DRAFT TECHNICAL MEMORANDUM

Subject: Lake Prevatt Minimum Flows and Levels Peer Review
Task B2: Draft Peer-Review Memorandum

Executive Summary

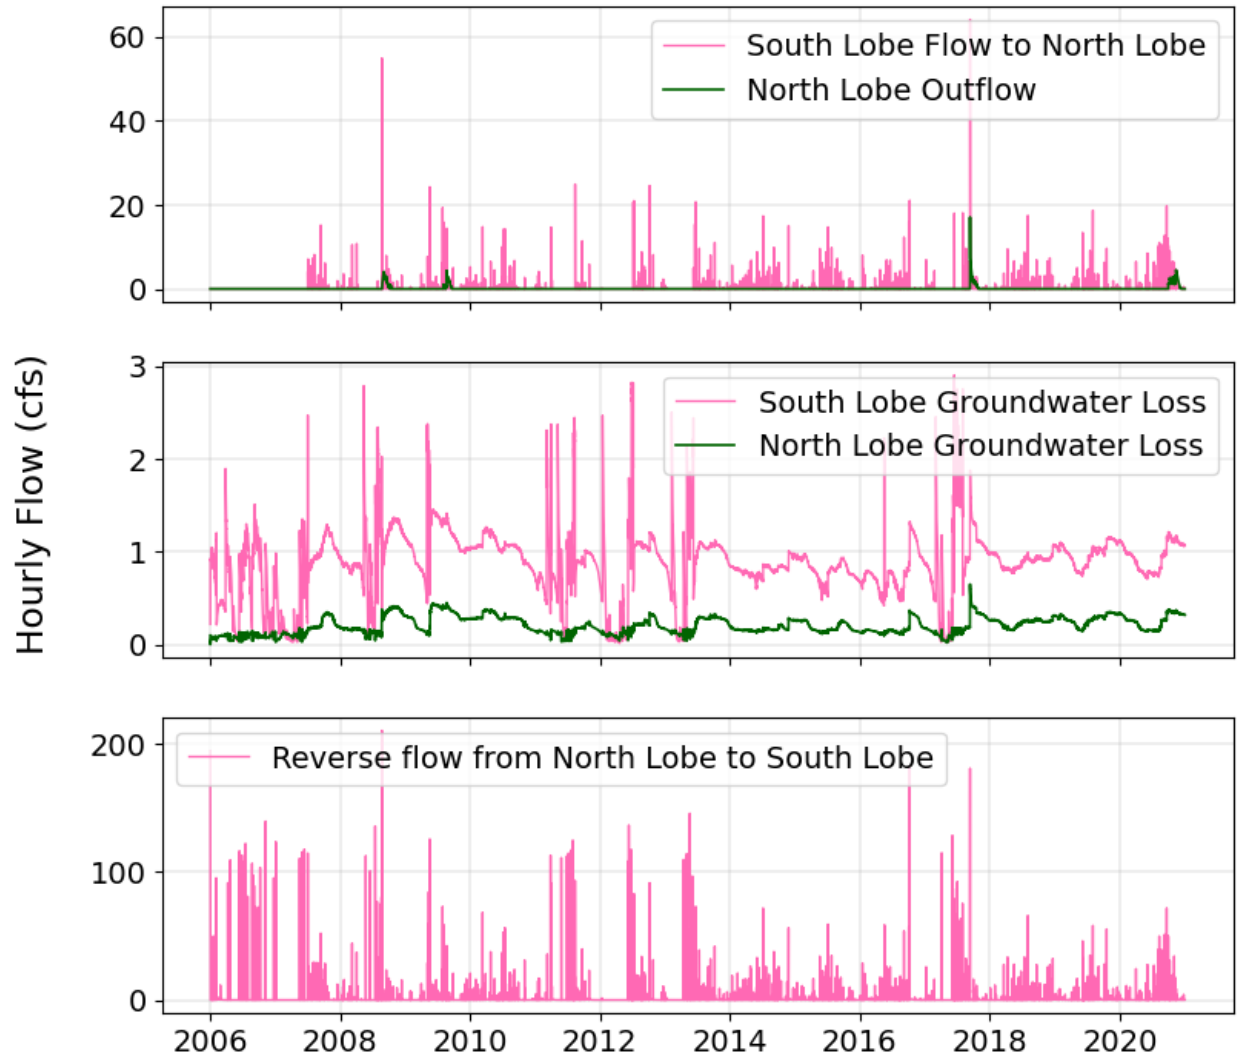
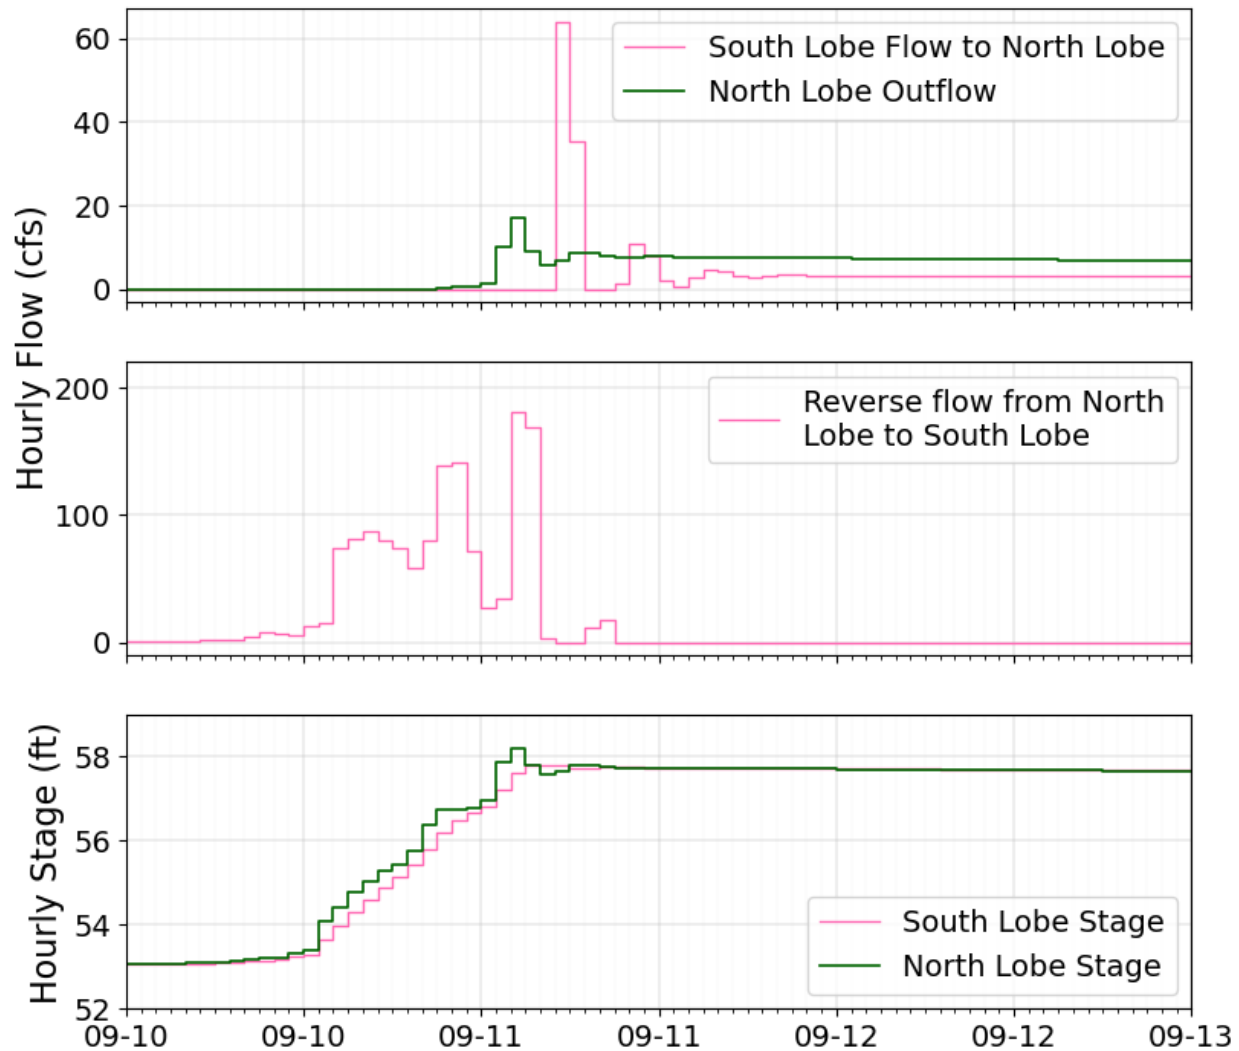
30. Sarker and others (2023) used a one hour computational time step. Maximum flow rate from the Lake Prevat south lobe to the north lobe was about 60 cubic feet per second, calculated at a one hour resolution, for one hour in late 2017 (**Figure 14**). Integrated over one day, this maximum reduces to below 2.5 cubic feet per second (**Figure 13**). Maximum flow rate from the Lake Prevat north lobe to the south lobe was about 200 cubic feet per second, calculated at a one hour resolution, for one hour in 2008 (**Figure 14**). Integrated over one day, this maximum reduces to about 35 cubic feet per second (**Figure 13**). Both the 60 cubic foot per second flow rate from the south lobe to the north lobe and the 200 cubic foot per second flow rate from the north lobe to the south lobe are, intuitively, not likely. The computational time step may contribute to these, perhaps, unrealistic flows from one lake lobe to the other lake lobe. Plotting one event at an hourly plot resolution (**Figure 15**) shows that stage differences of tenths of one foot force hourly flow rates of hundreds of cubic feet per second. SJRWMD may wish to reduce the computational time step from one hour to, perhaps, 15 minutes or 5 minutes. This shorter duration computational time step may allow water-surface elevations to equilibrate, reducing the duration over which a head difference between lobes maintained. This relatively shorter computational time step may reduce peak flow rates between lobes.

Figure 16. Rainfall depth during the (A) dry quarter of each year, in January, February, and March; and (B) wet quarter of each year, in July, August, and September, from 1892 to 2023. Rainfall depth from the Florida Climate Center (2023).

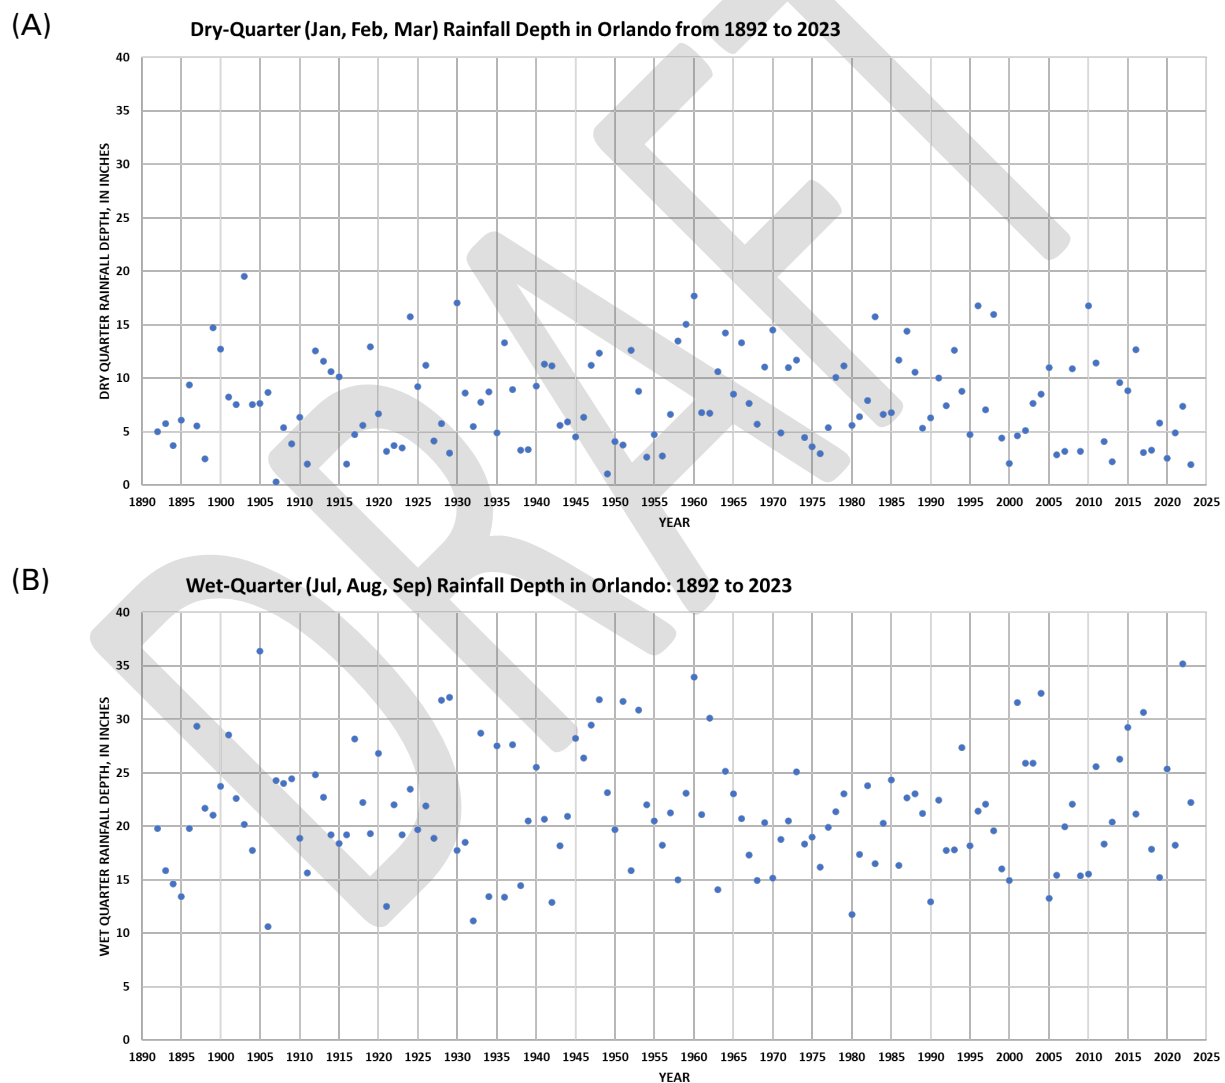
In the January 16 workshop, during which I presented initial comments, I shared a plot of dry quarter and wet quarter rainfall depth for Orland, from 1892 to 2023 (**Figure 16**). Strictly, these plots are not a rigorous examination of non-stationarity in meteorological forcing. However, visual inspection of these plots suggests that the historical variation in rainfall during the wet quarter appears to be stationary; and the historical variation in rainfall during the dry quarter also appears to be stationary.

Regardless of SJRWMD's use of adaptive management and regardless of downscaling challenges associated with use of global-climate models at a regional scale, SJRWMD may wish to scientifically determine whether Lake Prevat meteorological forcing statistically stationary or statistically non-stationary. SJRWMD may wish to use a more rigorous examination than simply plotting measurements, as I have done in **Figure 16**.

Figure 17. Simulated water balance in acre feet per year and as a percentage of inflow to the lake, to or from Lake Prevatt, from 2006 to 2020.

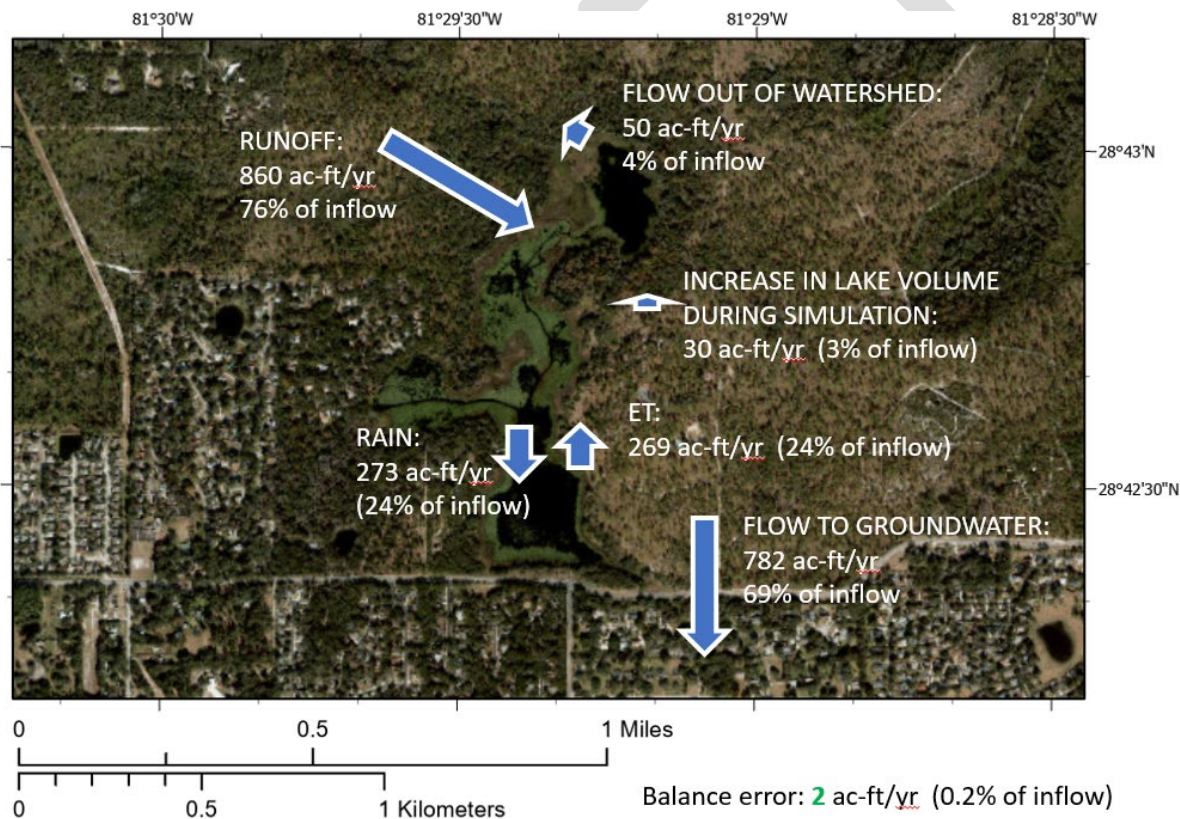
In the 2006-to-2020 simulation, 76 percent of inflow to Lake Prevatt is runoff and 24 percent is rainfall (**Figure 17**). Total inflow to Lake Prevatt is the sum of runoff and rainfall. In the simulation, groundwater outflow from Lake Prevatt is equivalent to 69 percent of total inflow to Lake Prevatt. Rainfall on the surface of Lake Prevatt is about the same as evaporation from the surface of Lake Prevatt. Surface-water outflow from Lake Prevatt to Carpenter Branch in Wekiva Springs State Park is about 4 percent of total inflow to Lake Prevatt.

Runoff and infiltration volumes are reasonable.
